**GOVERNMENT OF THE DISTRICT OF COLUMBIA
DEPARTMENT OF TRANSPORTATION**

MEMORANDUM

SUBJECT: ZC Case No. 14-07 – 1270 4th Street NE (EDENS Shapiro)

Figure 1 Site Design and Access (Source: Gorove/Slade)

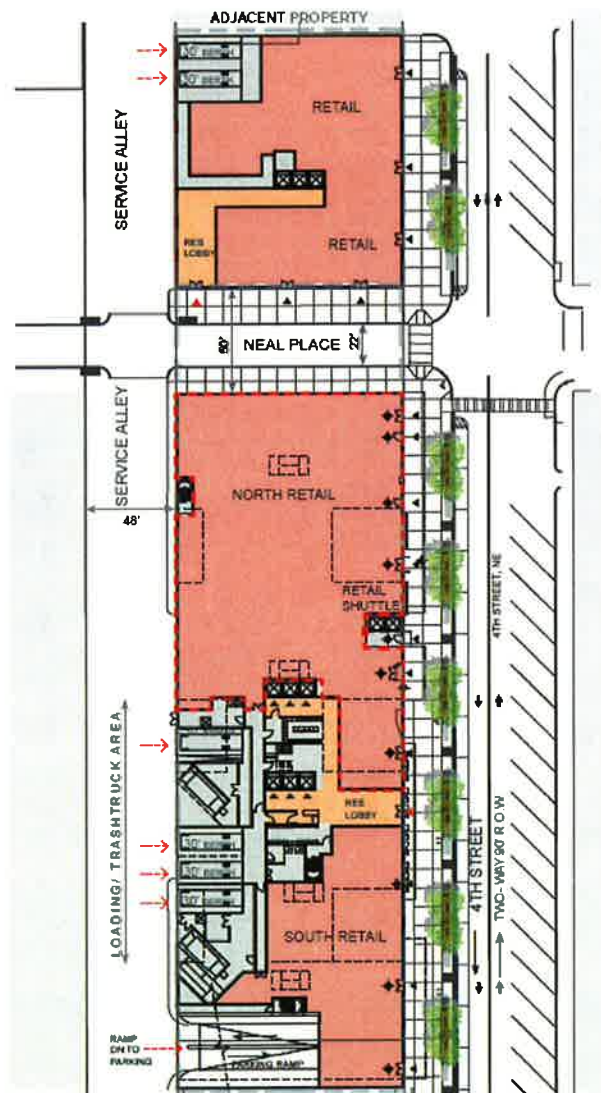
Vehicle site access for both phases of the project is proposed from an alley, in compliance with DDOT standards. Of note, the alley is controlled by the District through the Deputy Mayor for Planning and Economic Development, and is not DDOT right-of-way. See Figure 1 below for details.

Loading for both buildings is proposed via the alley. The loading facilities are designed such that loading is accommodated with front-in/front-out movements in compliance with DDOT standards. The Applicant's proposed loading locations comply with DDOT's loading requirements.

The Applicant's plans show curbside uses that includes angled back-in parking spaces along the east side of 4th Street. DDOT has not approved the proposed curbside uses as shown and does not support angled back-in parking spaces because of its impact to wholesaler operations. The Applicant has agreed to coordinate with DDOT on the development of a curbside management plan for the entirety of 4th Street between Florida Avenue and Penn Street. The details of the plan, which must account for the needs identified above, will be determined as part of the public space permitting process.

Figure 4 - Neal Place Interim Proposal

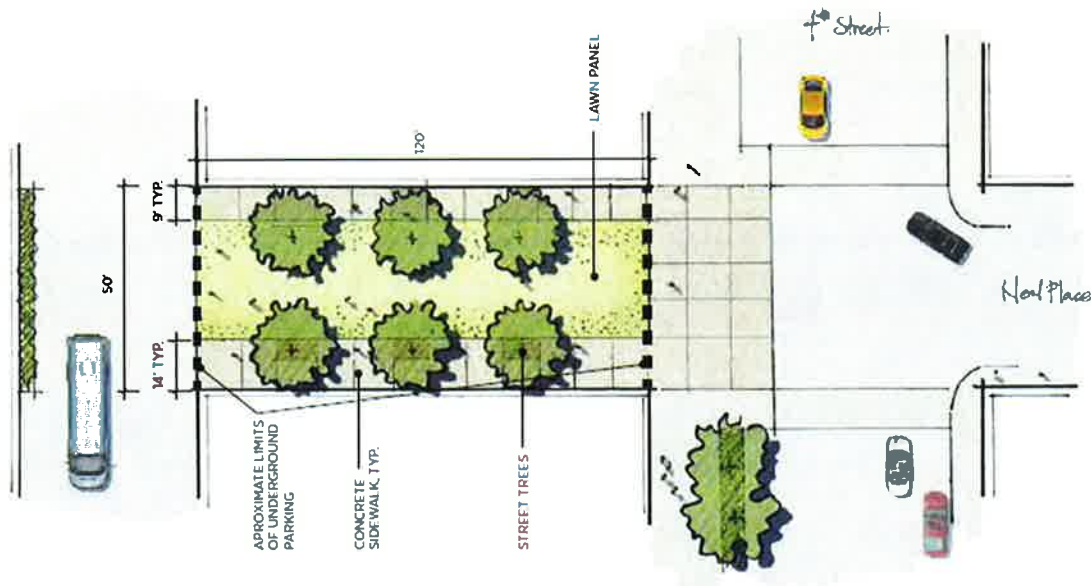
The Applicant proposes an interim park in the Neal Place ROW that transitions to a street in the future. The interim condition would involve building out the sidewalk and tree box components of the extension and portions of the underlying roadbed infrastructure, but would include a park in place of the 22' cart path. Some construction would be required in order to transition from the interim park use to the final road condition. The Applicant estimates that conversion, including the securing of necessary permits, could take up to 12 months.

As discussed above, the Neal Place extension is critical to disperse site-generated traffic and support development within the Market, particularly developments to the west of 4th Street. While a temporary use of the space as a park may be appropriate, it is critical that the interim use be limited only to times when the connection is not needed to support development in the Market or for dispersing site-generated traffic to improve the operations in the vicinity.

DDOT finds these triggers as a good basis for transitioning from an interim use to the final condition, but the following adjustments are needed to provide greater assurances that the Neal Place extension opens in a timely manner:

Prior to the issuance of a certificate of occupancy for the South Parcel building, the Applicant shall demonstrate that it has constructed the interim Neal Place extension improvements as shown on the Interim Neal Place Extension Plan.

The Applicant shall secure the necessary funds in an escrow account and shall design and construct the final Neal Place extension improvements as shown on the Final Neal Place Extension Plan and open the Neal Place extension to vehicular traffic within twelve (12) months of the earlier of the following events. When:

- After review of a Monitoring Study that demonstrates queuing extending more than 150’ on 4th Street south from Morse Street toward Florida Avenue on more than one (1) observation day, and DDOT concludes and communicates to the Applicant that the Neal Place Extension is needed to alleviate traffic queuing conditions at 4th and Morse Street. Each Monitoring Study should document whether queuing was the result of
